Project  
Whitkirk, St Mary's - Alterations

Drawing Title  
Electrics as Proposed - Phase 1

File Name  
5786-PBA-XX-XX-DR-A-6001

New Flooring and Electrics Section

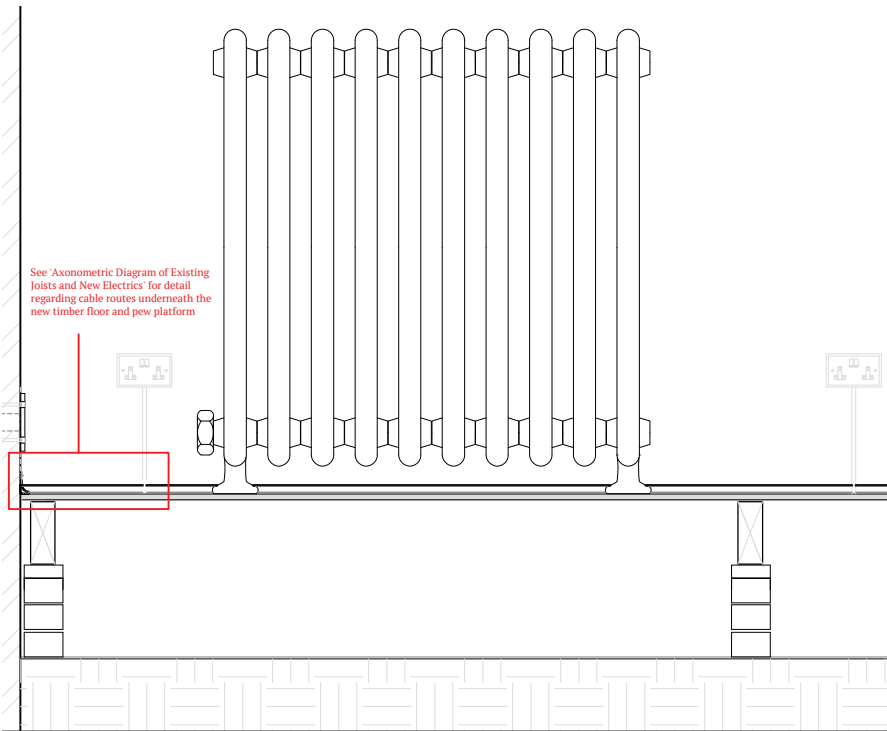
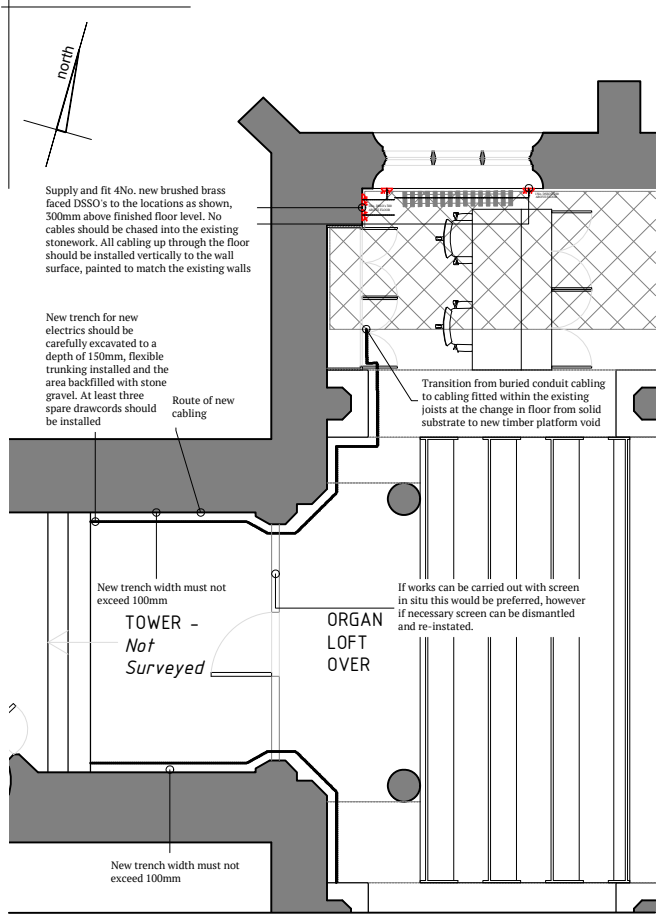
C03 AW 02/01/24 Updated following comments by the DAC.

C02 AS 30/05/23 Conduit changed

The contractor should ensure that all cables installed under the pew platform floor are to not be liable to damage by contact with the floor or any of their fixings which should be assessed following breaking out. Where a cable must pass through a timber joist within a floor the cable must either be minimum 50mm measured vertically from the top or bottom as appropriate or comply with Regulation 522.6.203 (metal sheathed cabling, thick metal plate over, etc.) Submit proposals for the most appropriate method following breaking out.
